**COMMUNITY DEVELOPMENT
DEPARTMENT REPORT**

HEARING DATE: 5/12/2026
TO: Mayor & City Council
FROM: Bill Parsons, Planning Supervisor
bparsons@meridiancity.org
Linda Ritter, Associate Planner
lritter@meridiancity.org
208-884-5533
APPLICANT: Laren Bailey, Conger Group
SUBJECT: H-2026-0001
Skybreak Rim MDA, PP, RZ
LOCATION: Near the SEC of S. Eagle Road and E. Lake Hazel Road, located in the NE ¼ of the NE ¼ of Section 4 Township 2N, Range 1E Parcel # S1404212755

Note: See City/Agency Comments and Conditions Section and public record for all department/agency comments received. Skybreak Rim Subdivision MDA, PP, RZ H-2026-0001 (copy this link into a separate browser).

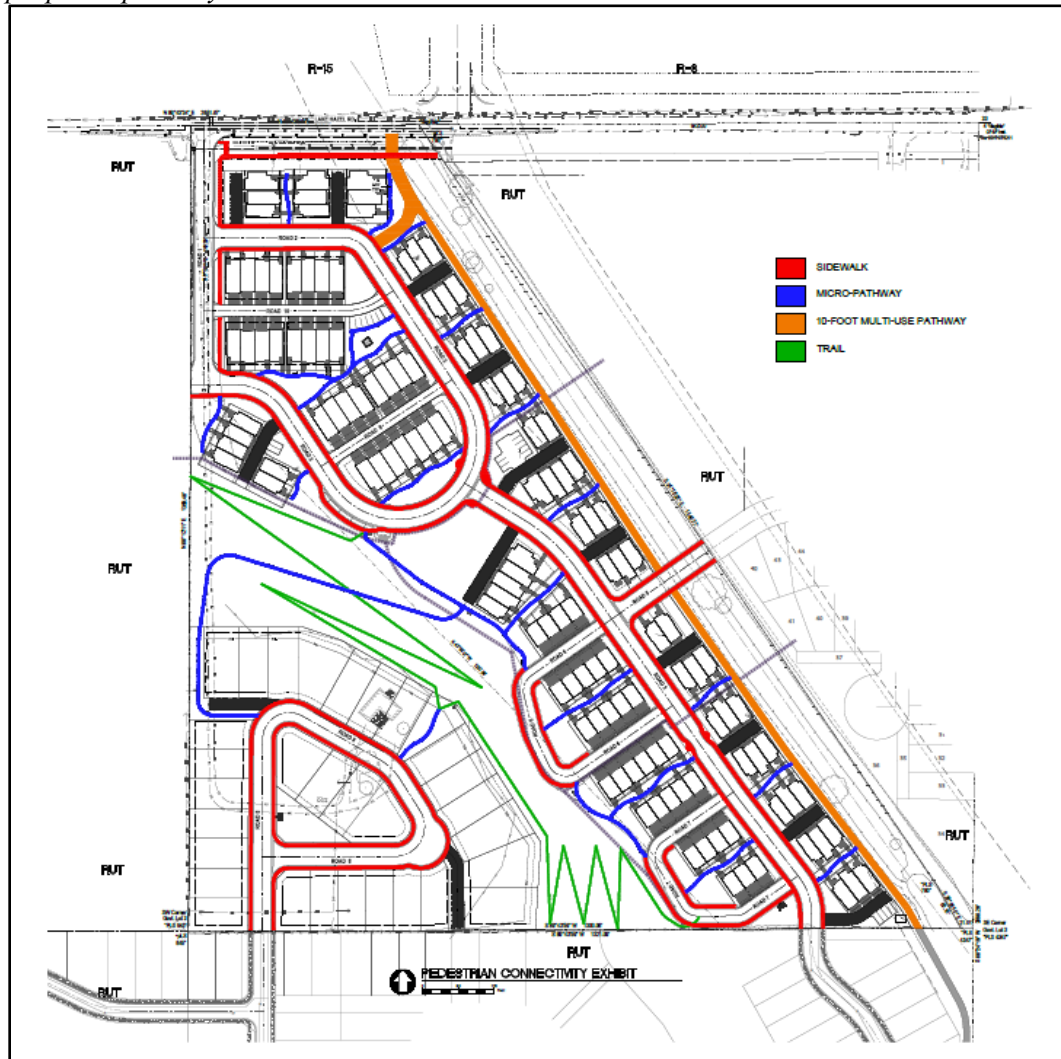
The applicant is proposing a pathway on the north side of the property that connects to a foothill trail descending the slope. This trail will be designed as a natural switchback along the hillside, with disturbed areas reseeded and maintained in a natural condition. In addition, a separate pathway is proposed within the open space area along the private road. This pathway is standalone and does not directly connect to existing sidewalks or other pathway systems.

The applicant needs to update their pedestrian circulation exhibit to show how they plan to connect the proposed pathway below the slope to Pura Vita Subdivision.

Pedestrian Connectivity Exhibit

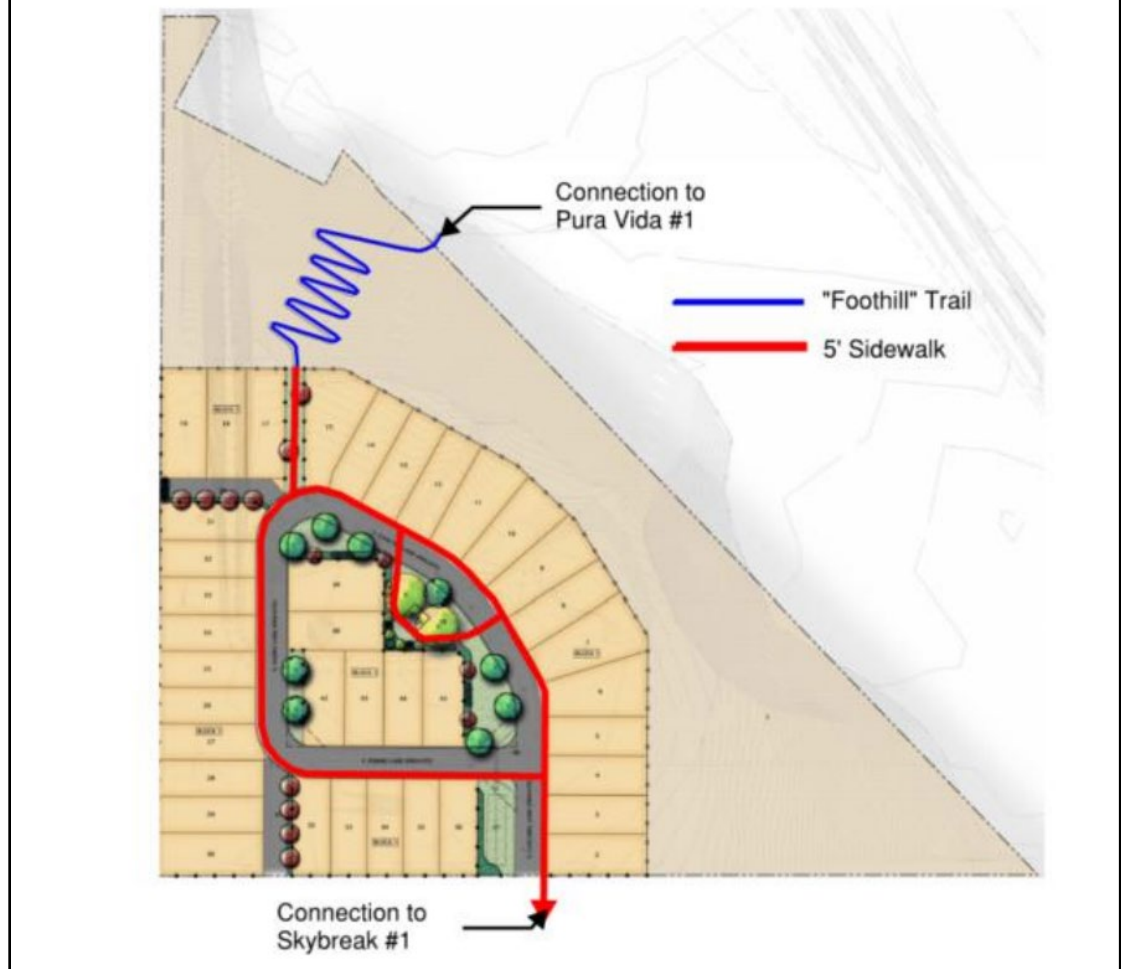
The previous approval provided sidewalks on both sides of the public street connecting to the proposed pathway network as seen in the exhibit below.

The applicant is proposing a private street with a 5-foot sidewalk on the east side which does not meet the requirements of UDC 11-3F-4.C.2.b. The applicant is requesting a waiver to design the same street section and sidewalk configuration approved with the original Skybreak Subdivision (see exhibit below).

As the private street section of the UDC was changed in 2025, the Planning Commission and City Council should carefully consider whether the proposed request meets the intent of the current UDC for sidewalks associated with private streets.

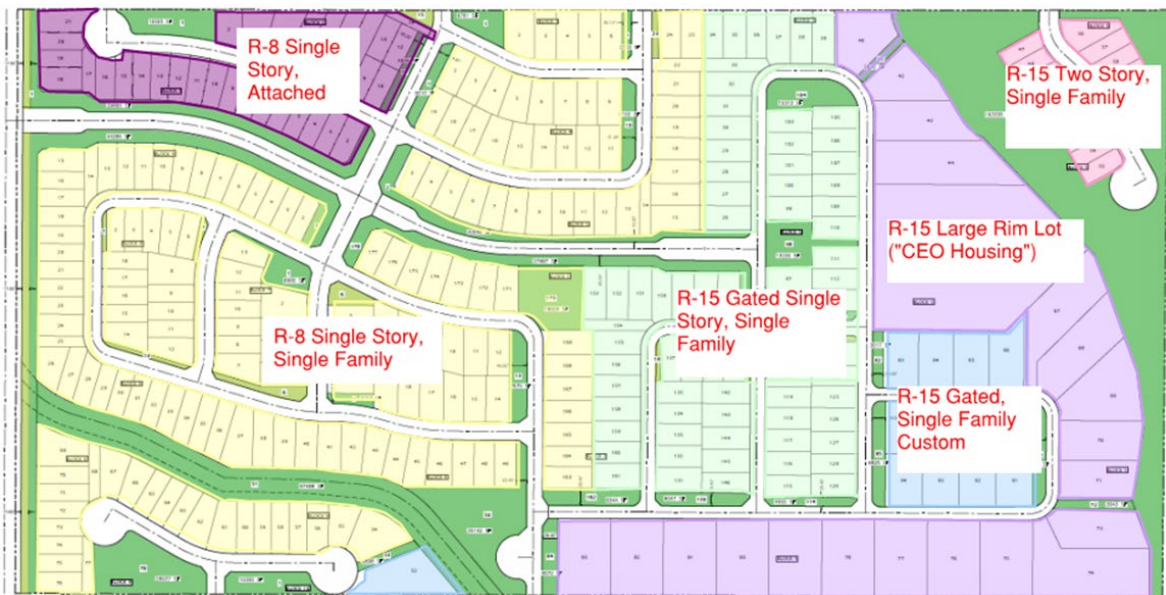
The applicant is required to comply with the private street requirements outlined UDC 11-3. To serve the 38-lot development the applicant is proposing private streets. In doing so, they are proposing to utilize the existing private street network within the Skybreak development. While the proposed subdivision does not include additional gates, the development will connect to and rely on the existing private streets and gated entrances that currently serve the Skybreak community.

The City Council previously approved the Skybreak development with 106 homes served by private streets and two (2) gated accesses. The current proposal would add an additional 38 homes to the private street network.

Pursuant to UDC 11-3F-4, gated residential developments served by private streets shall have no more than one hundred (100) dwelling units, unless a greater number of units is approved through a planned unit development (PUD). The code in effect at the time required

one gated entry for every fifty (50) dwelling units. Given that the previously approved development already exceeded the 100-unit threshold and the applicant is proposing to add an additional 38 homes to the existing private street network, the Planning Commission and City Council should carefully consider whether expanding the number of homes served by this private street system remains appropriate and consistent with the intent of the Meridian City Code.

Additionally, in order to facilitate the proposed connection to the existing private street network, the applicant is required to modify the existing Skybreak Subdivision plat. Specifically, one of the buildable lots within Skybreak Subdivision (Lot 13, Block 1) must be converted to a common lot to accommodate the connection and circulation associated with the private street system. As a result, the applicant will be required to submit a final plat modification for Skybreak Subdivision and a concurrent private street application to allow the proposed connectivity. These applications must be reviewed and approved by the City prior to submittal of the final plat for the proposed subdivision.

2. The applicant shall submit a final plat modification for Skybreak Subdivision and a concurrent private street application to allow the proposed private street access. These applications shall be reviewed and approved by the City prior to submittal of the final plat for the proposed subdivision.
